**From:** Morel, Brian P [Brian.Morel@bp.com]  
**Sent:** Thursday, April 15, 2010 4:00 PM  
**To:** Jesse Gagliano; Hafle, Mark E; Cocalles, Brett W; Walz, Gregory S  
**Subject:** RE: OptiCem Report  
**Attachments:** image002.jpg; image003.jpg

**To:** Hafle, Mark E; Morel, Brian P; Cocales, Brett W; Walz, Gregory S  
**Subject:** OptiCem Report

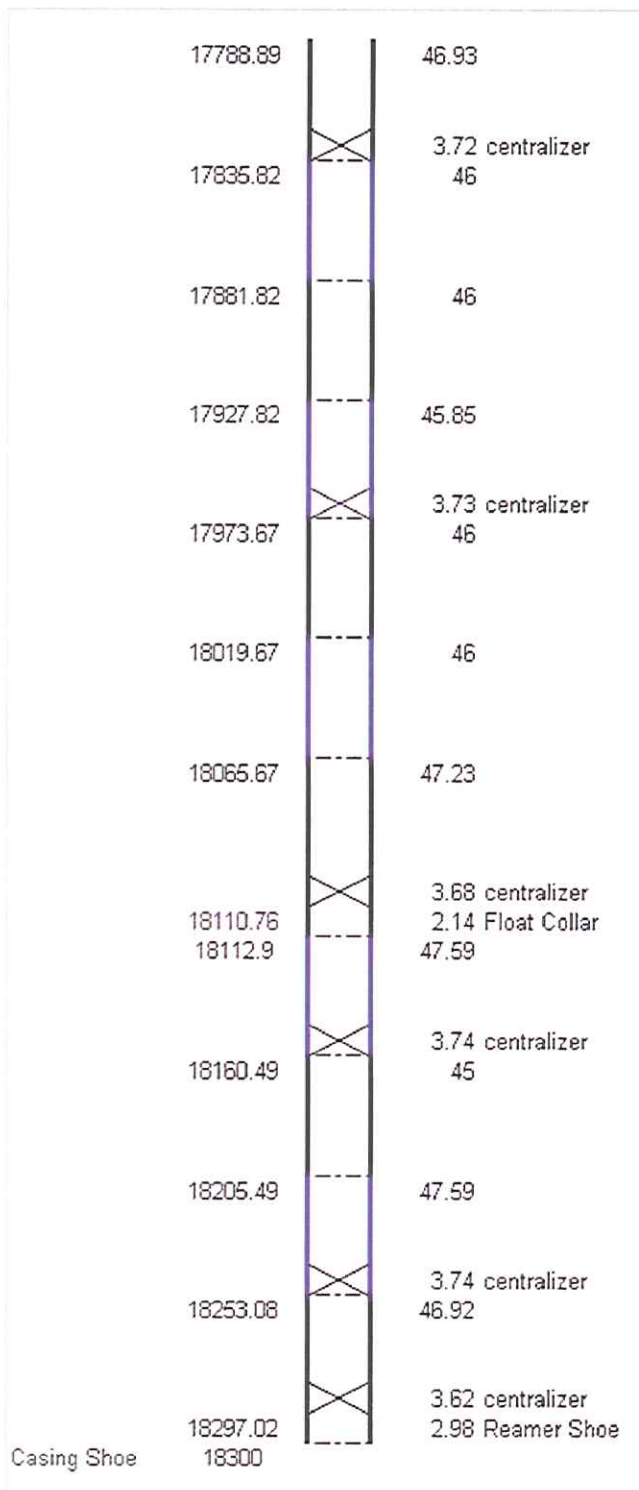
We have 6 centralizers, we can run them in a row, spread out, or any combinations of the two. It's a vertical hole so hopefully the pipe stays centralized due to gravity. As far as changes, it's too late to get any more product to the rig, our only options is to rearrange placement of these centralizers. Please see attached diagram for my recommendation.
